Further and Final Supplementary Response to Submissions

UTS City Campus, Broadway Precinct
GFA and Building Envelope Amendments

Submitted to Department of Planning and
Environment
On behalf of University of Technology Sydney

12 November 2019 | 218424

Figure 1 Proposed amended envelope looking north-west

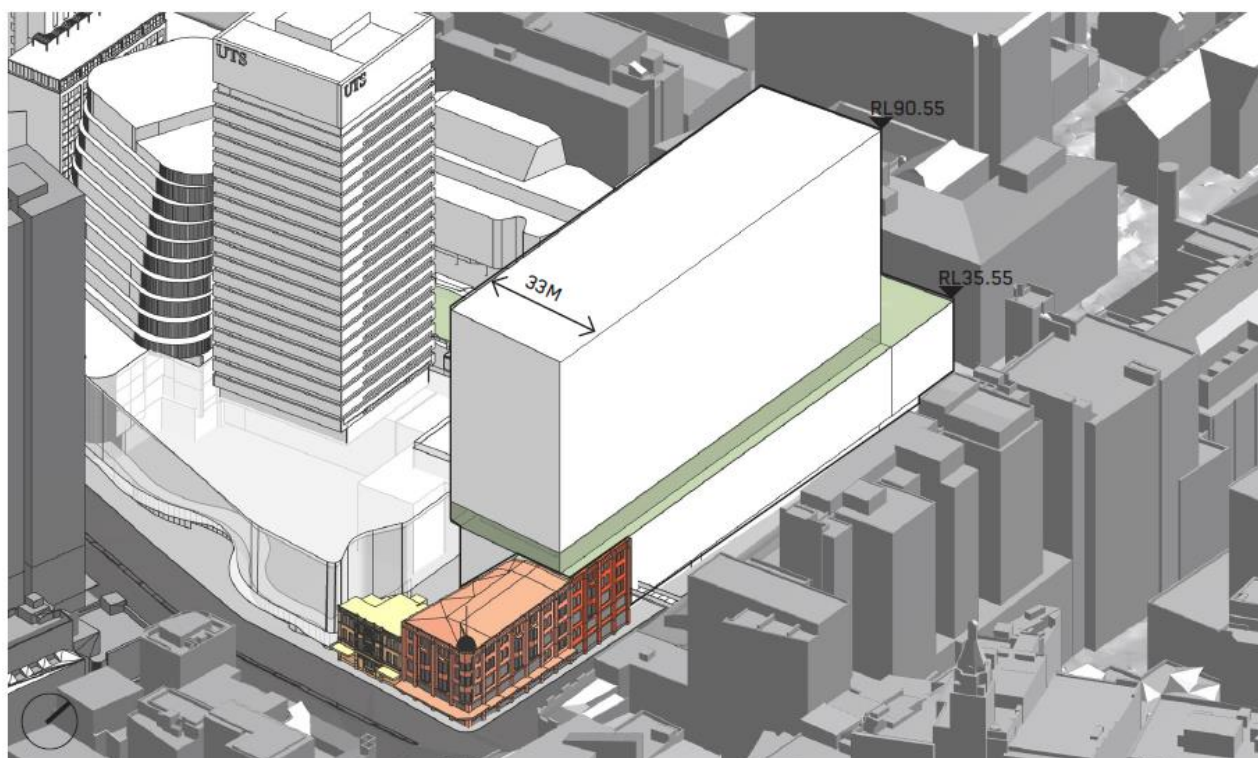
- Conceptual demolition of existing Building 4, and rear section of Building 3,
- Conceptual modification to heritage items, Building 3, Building 9, and Building 18;
- Creation of a new building envelope for Building 4 and Building 3 (part), resulting in a maximum height of RL 90.55, an increase of approximately 49m above existing Building 4 and approximately 54m above existing Building 3;
- Corresponding increase in GFA for Building 4 and Building 3, comprising an additional increase of up to 36,500m² (with a limit of 26,500m² additional GFA above ground);
- Consequential amendments to the Urban Design Quality Controls/Principles to guide the future development of the Bon Marche and Science Precinct; and
- Indicative landscape and public domain concept for the precinct.
